**Landscape Review Committee**  
**Community Development Center, 231 NE 5<sup>th</sup> Street**  
**January 18, 2017**  
**12:00 PM**

**DATE:** January 18, 2017  
**TO:** Landscape Review Committee Members  
**FROM:** Chuck Darnell, Associate Planner  
**SUBJECT:** Agenda Item 4A: L 36-16

**McMinnville High School Addition and Remodel - Phase 1**  
**McMinnville School District**  
 615 NE 15th Street, McMinnville, OR 97128  
 t: (503) 565-4000  
 f: (503) 565-4030

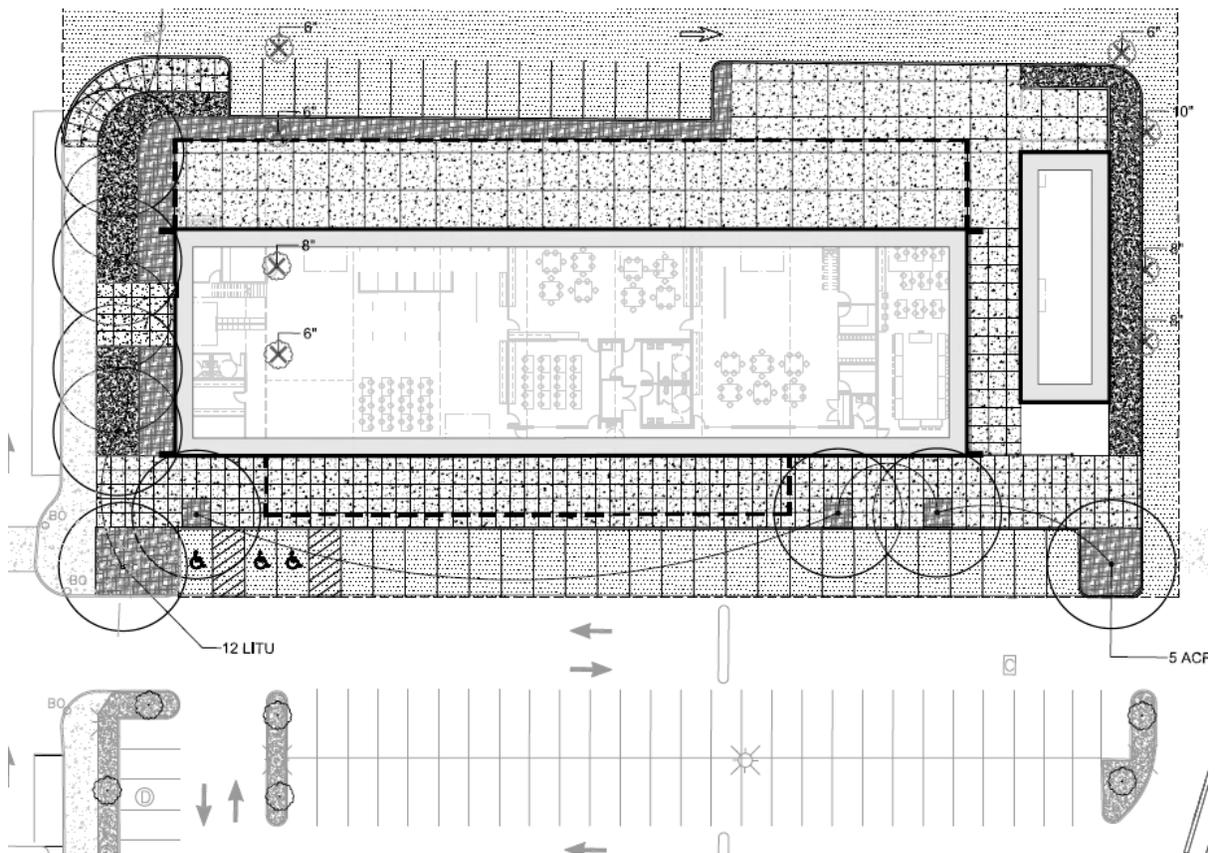
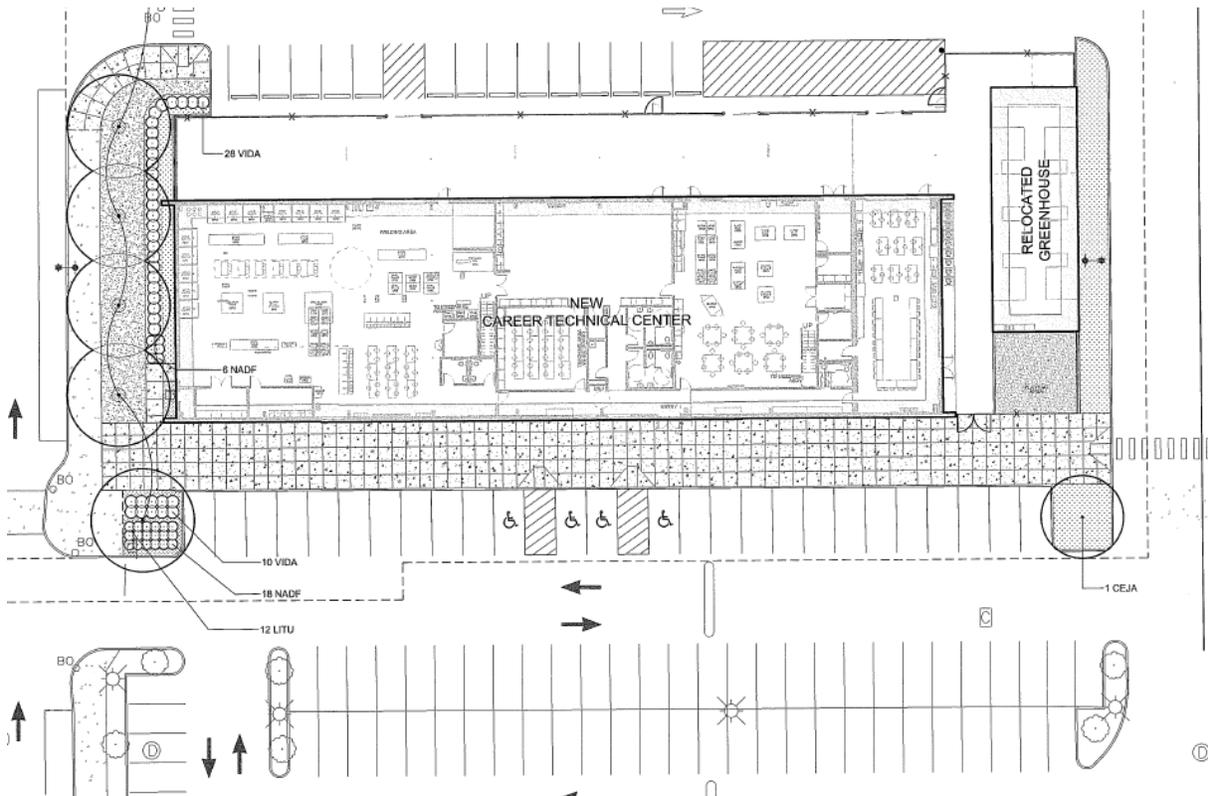
The new Technology Center building had been shown to have additional trees planted on the south side, between the new building and the existing parking lot, during the review of the recent conditional use request (CU 8-16). However, those trees are not shown on the submitted landscape plan. The original landscape plan from the conditional use permit review can be seen below:

The landscape plan as submitted can be seen below, which does not include as many trees along the south side of the Technology Center:

Staff believes that the original landscape plan and the additional trees on the south side of the building provided for buffering between the building and the pedestrian space and the adjacent parking lot. Therefore, staff is suggesting that additional trees be added back to the south side of the Technology Center, as shown in the plans submitted for the conditional use review.

1. That the applicant install landscaping as shown on the submitted landscape plan dated December 16, 2016.
2. That three (3) additional trees be installed on the south side of the Technology Center as shown in the landscape plan from the plans submitted for the review of the conditional use (CU 8-16) dated October 7, 2016.

**PLANTING PLAN**  
**L2.01**

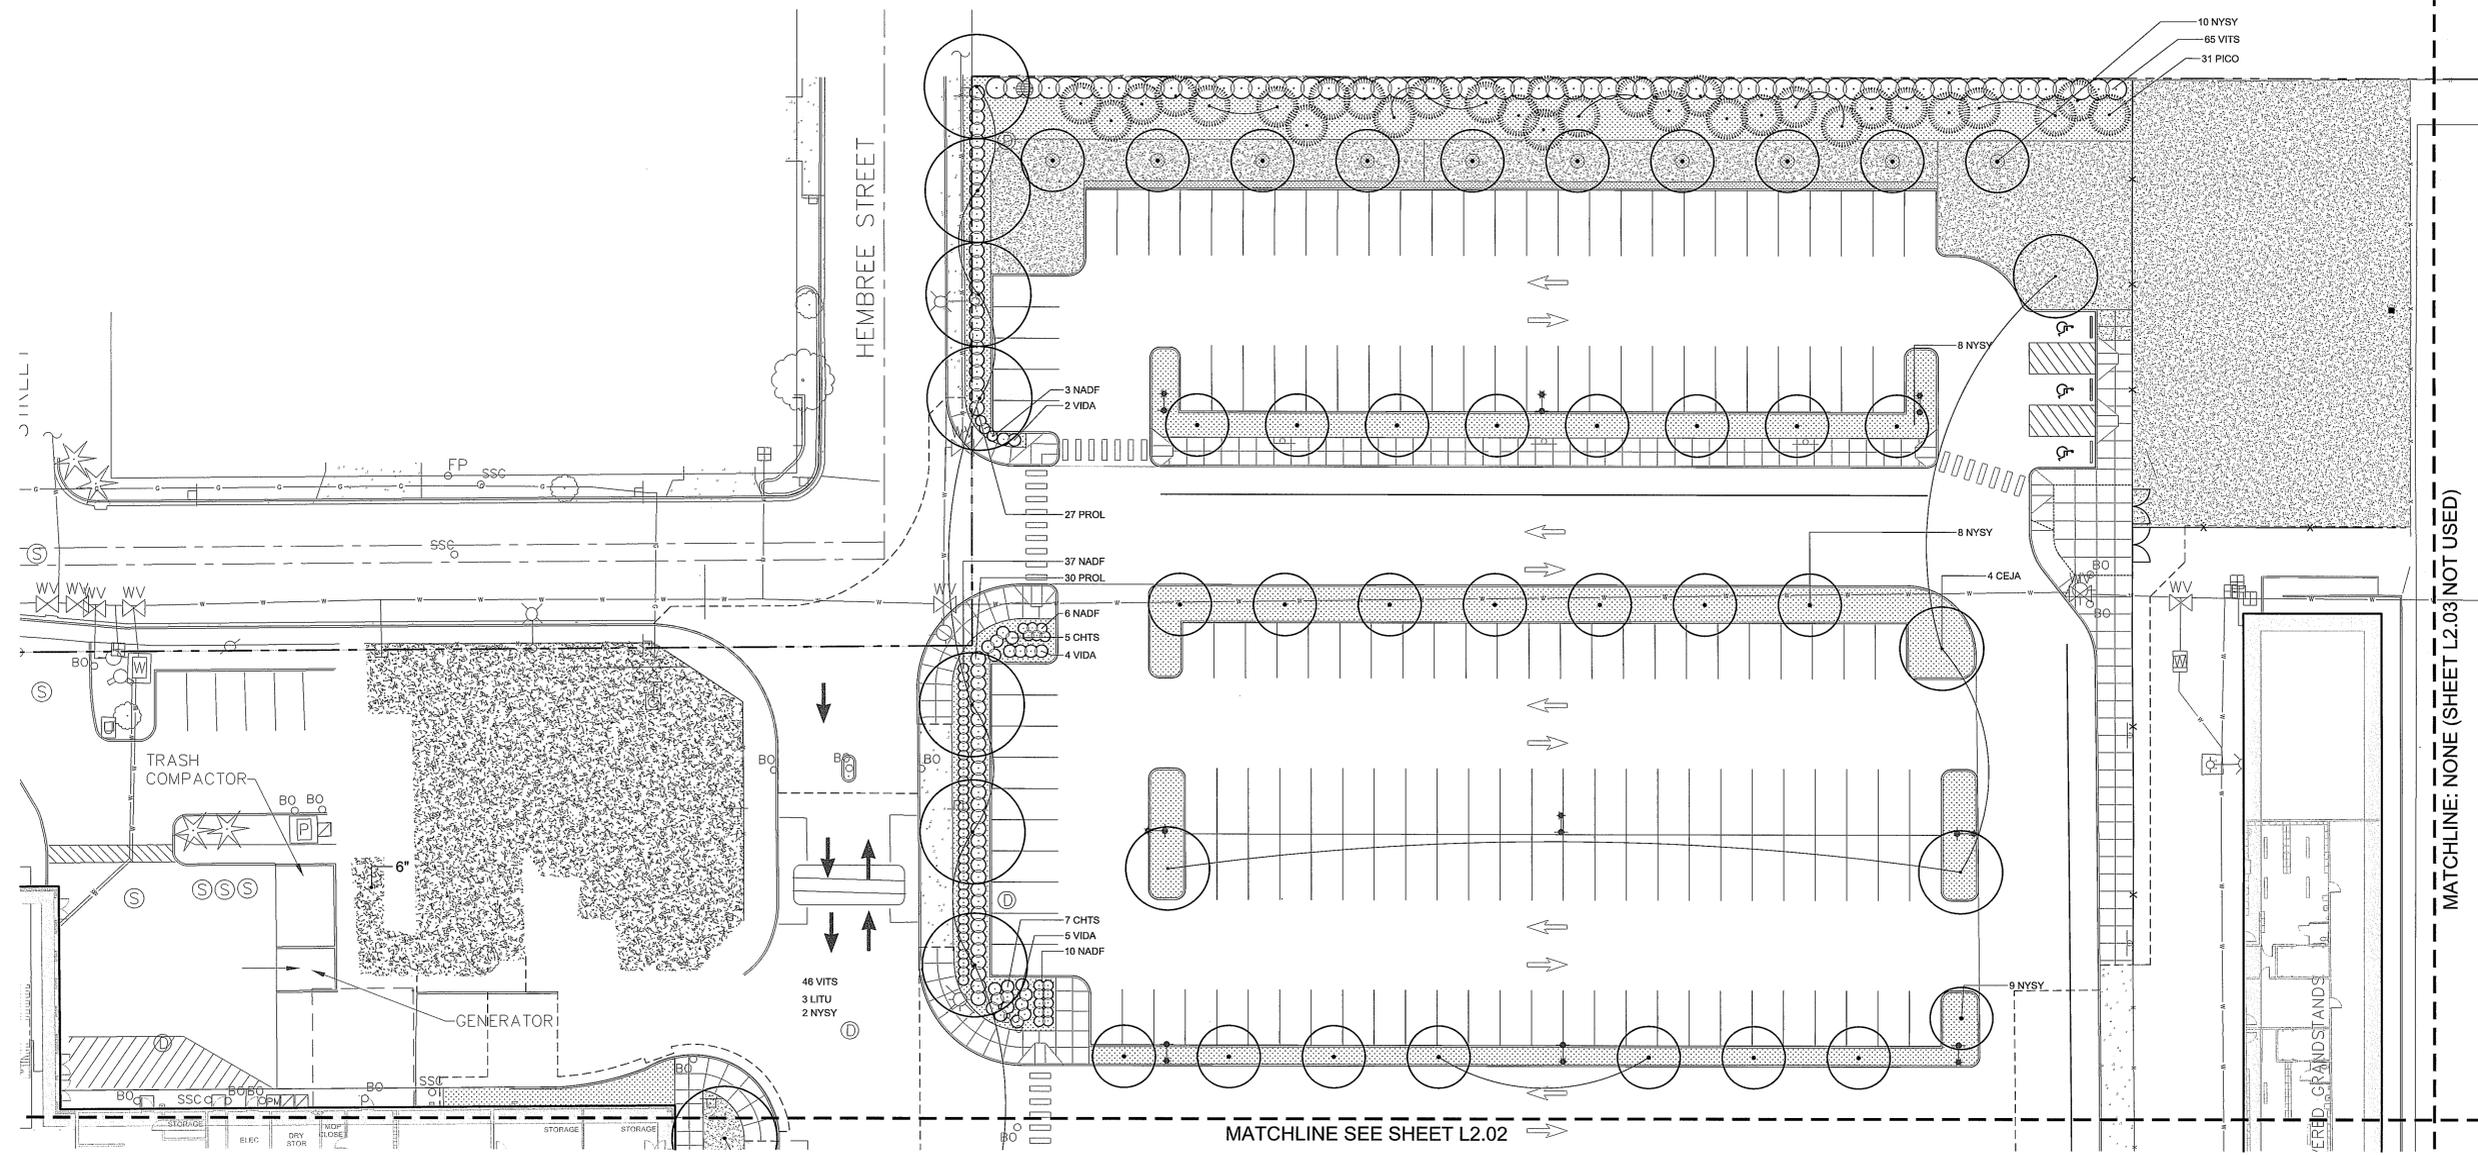
1. The only planting either in the right of way, or directly adjacent, would along Hembree, north of the intersection with 17<sup>th</sup>. The proposed trees at that location, Lirodendron tulipifera, is on the City's approved street tree list. The spacing at this location appears to be about 30', which meets the City's ordinance requirements.

2. From the drawing it appears that the intended location of these trees is behind the sidewalk, and just outside the right of way. If the trees are to be planted in the right of way, then the applicant should be required to plant as per the City's planting detail, and to call Public Works for an inspection prior to backfilling. Given that the plans show irrigation, the requirement for deep watering tubes can be waived. If the trees are to be located outside the public right of way, although outside our purview, staff might suggest that the applicant still consider installing root barrier protection as per the City detail to protect the adjacent sidewalk.

The species of trees in that specific location along NE Hembree Street could be adjusted to another species with a smaller mature canopy. The species could be selected from the "Small Trees" on the approved McMinnville Street Tree List, which were selected as appropriate species for planting underneath overhead utility lines because their mature height is 25 feet or less. Also, although the trees are being planted outside of the right-of-way, root barrier protection could be required on the trees along NE Hembree Street to prevent any future damage to the adjacent sidewalk. Root barrier protection could also be encouraged adjacent to the Emerald City Tulip trees along the drive aisle to the south to ensure that the sidewalks within the site are not damaged in the future.
